OCPP 1.6 Errata sheet

2025-04

Errata sheet: for OCPP version: 1.6 edition 2 and 1.6 FINAL.

Figure 1. Sequence Diagram: get diagnostics

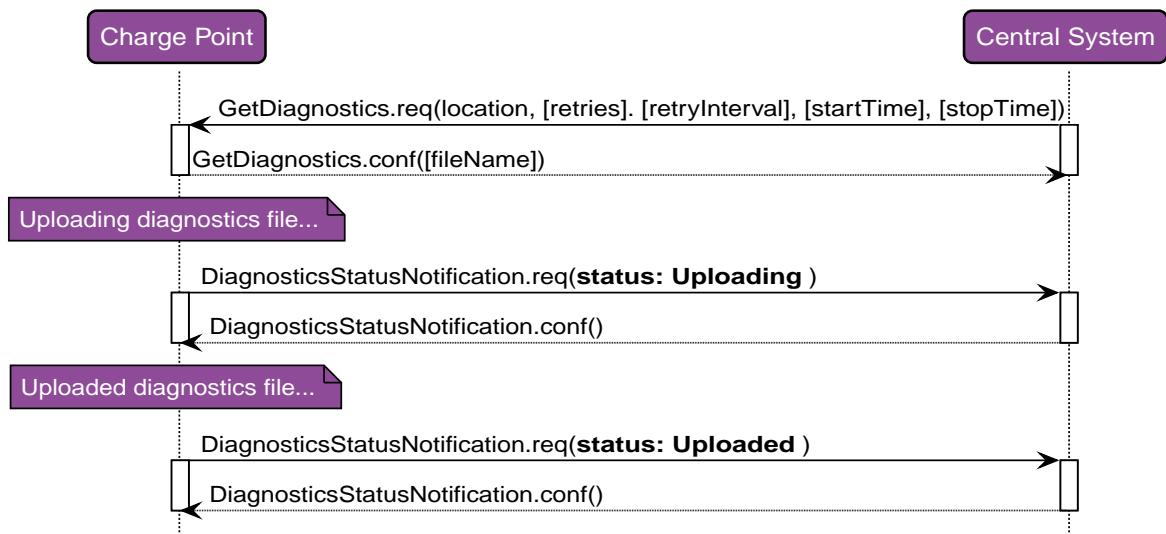
3.31. Page 51, section: 5.9: Relation between GetDiagnostics.req and DiagnosticsStatusNotification.req is missing.

There is no description about the relation between GetDiagnostics.req and DiagnosticsStatusNotification.req in the specification.

The following diagram should replace the diagram in 5.9.

Additional text	During uploading of a diagnostics file, the Charge Point MUST send DiagnosticsStatusNotification.req PDUs to keep the Central System updated with the status of the upload process.
-----------------	---
